EAST TOWN CROSSING MULTIFAMILY

PLAYGROUND EQUIPMENT

EAST TOWN CROSSING
PLAYGROUND EQUIPMENT
3002 E PIONEER PUYALLUP WA 98372

AGENCY REVIEW | 25.12.10

2 ENLARGED SITE PLAN - PLAYGROUND AREA

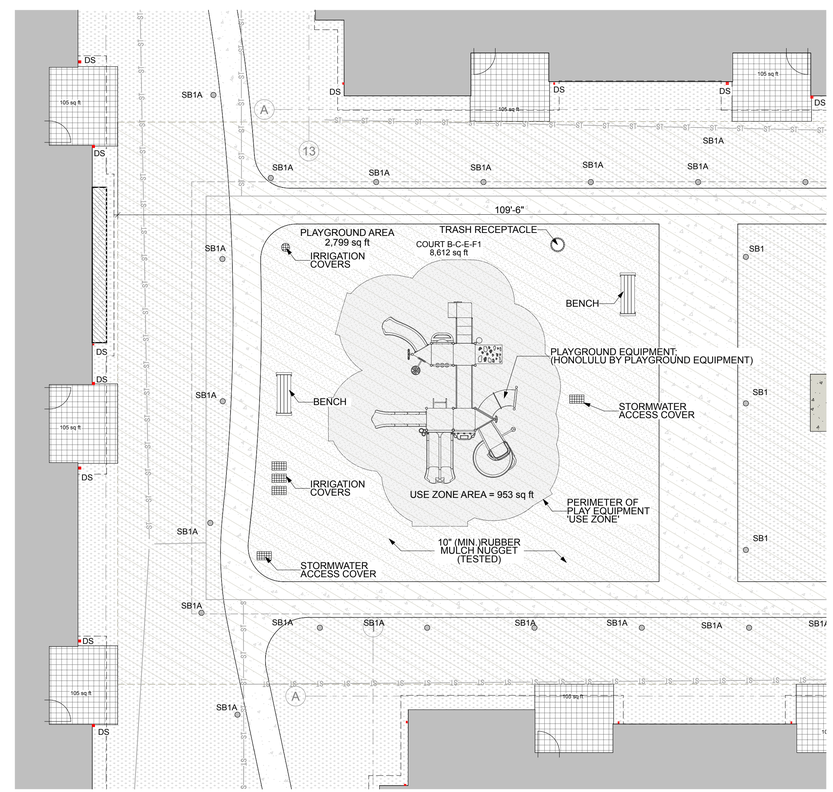
Provide a letter from the project's Engineer-of-Record addressing the following:
1) The original stormwater design indicated the area of the proposed playground to be non-pollution generation lawn surface. Is there a water quality concern with the use of the 10in thick rubber mulch surfacing? Is the material inert? Provide supporting documentation if there is no water quality concern.
2) There is no impact to the flow control facilities due to the addition of the playground equipment.
3) There is no impact to the RTank below the proposed playground equipment considering the associated footing depth required for the equipment.

Provide a letter from the project's Engineer-of-Record that the imposed dead and live loads of the proposed playground will not damage the RTank below the playground or, in any way, alter the capacity or function of the RTank.

Provide an elevation detail or profile of the proposed playground footings in relation to the existing RTank and backfill. The "Example of Footer" found in the submitted playground equipment specification does not adequately identify the separation between the footers and the distance from the minimum 12" of free draining backfill stone above the tank.

No proposed footings, posts, or supports shall be constructed on or above any existing public utility connections without first relocating the utility services or protecting it in place.
